# ASSESSMENT OF HYDROLOGIC FACTORS GIRU BENEFITTED AREA

Toby McGrath
Water Solutions Pty Ltd

16 October 2019

### A Basis For Pricing - The Model

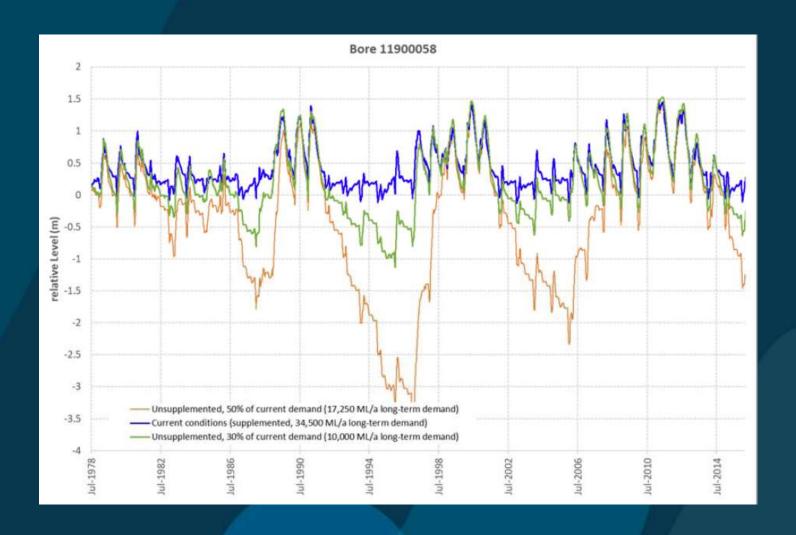
- Use of model for pricing is not recommended -Nevertheless, an assessment of the reported results was performed.
- For the unsupplemented case to provide a valid measure of unsupplemented yield, it must provide the same:
  - Allocation performance, and
  - Environmental performance
- Allocation performance
  - 30% and 50% unsupplemented cases do deliver the indicated demand – same allocation performance as supplemented case
  - However, some difference in access (surface vs groundwater)
